**CORRESPONDENCE COVER SHEET
WASTE PERMITS DIVISION
TEXAS COMMISSION ON ENVIRONMENTAL QUALITY**

Date: May 17, 2019
 Facility Name: City of Kingsville Landfill
 Permit or Registration No.: MSW 235-C

Re: City of Kingsville Landfill – Kleberg County
Municipal Solid Waste (MSW) - Permit No. 235C
Permit Amendment Application – Supplemental Information
Tracking No. 23301130, 23458984, and 24040819; RN102334570/CN600674246

On behalf of the City of Kingsville and in response to your May 10, 2019 and May 16, 2019 email requesting supplemental information, we hereby submit the enclosed response regarding the Permit Amendment Application for the above referenced MSW facility.

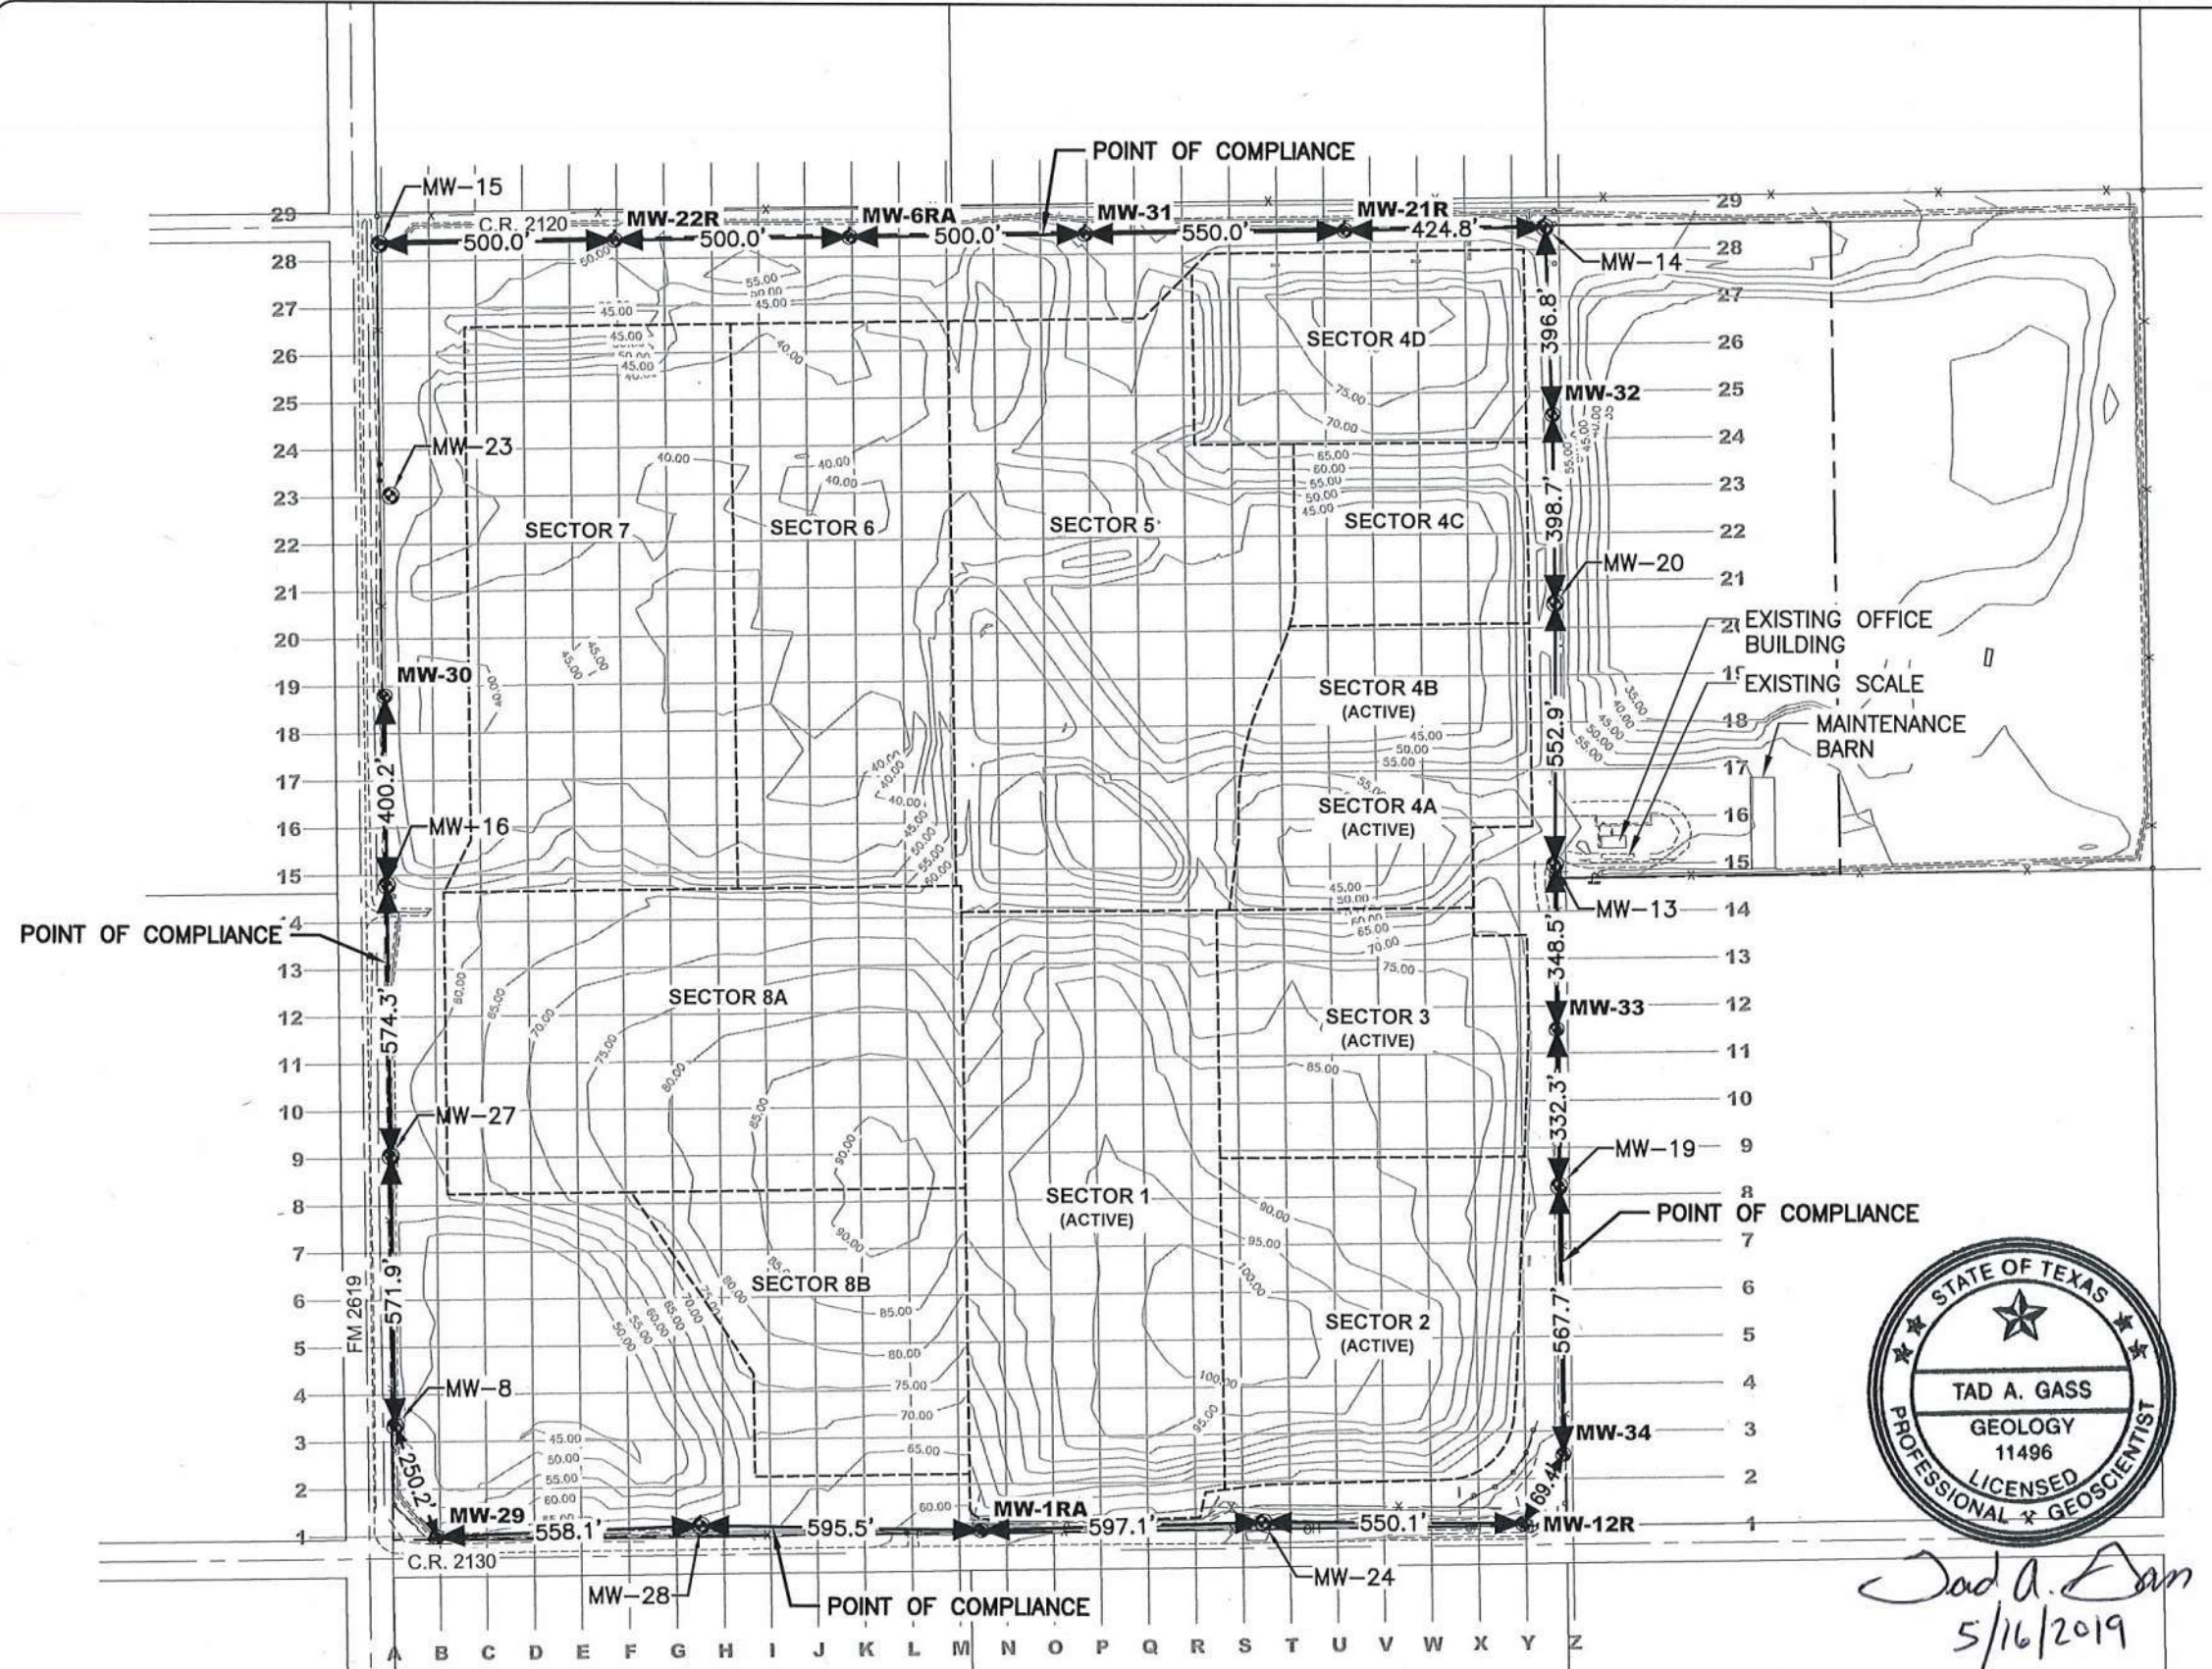
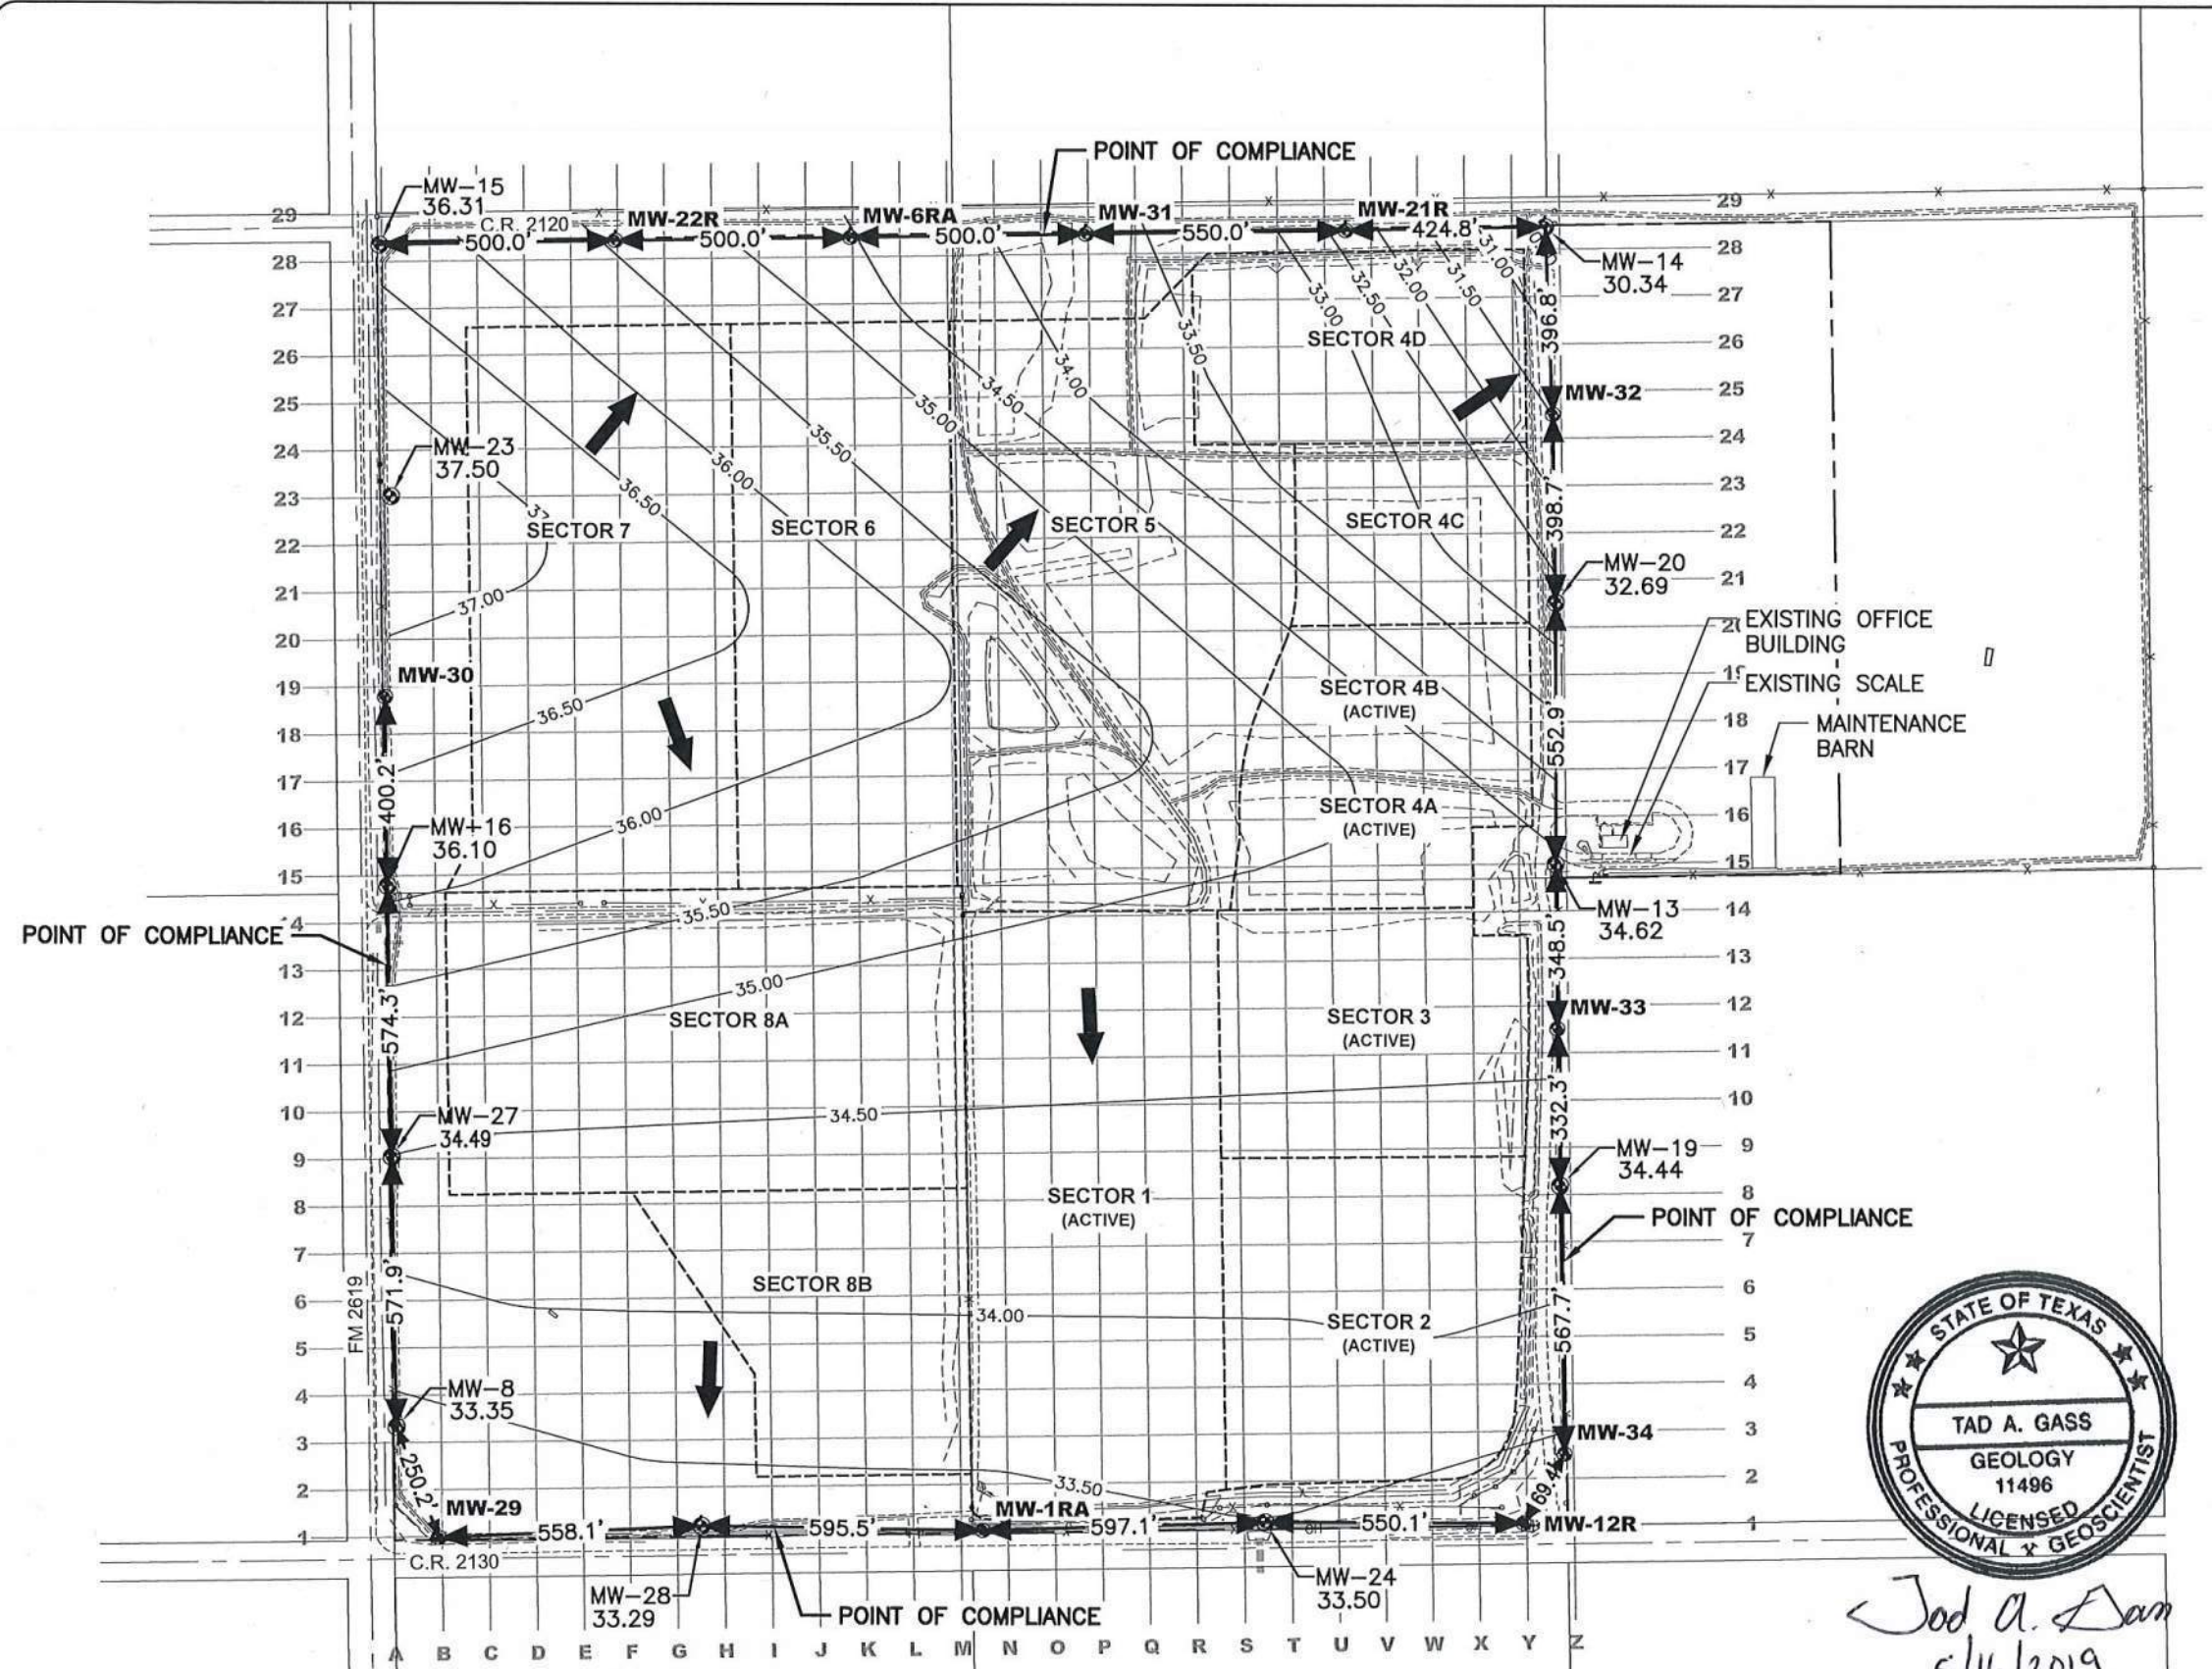
Att 11, App A, Item 1	Ambiguous
NOD Description	
Highlight the point of compliance line on Figures III.11-A-1A and 1B to more clearly show its extent, and provide a schedule for monitor well installation.

The point of compliance line on Figures III.11-A-1A and 1B has been highlighted with arrows to more clearly show its extent, and to provide a schedule for monitor well installation.
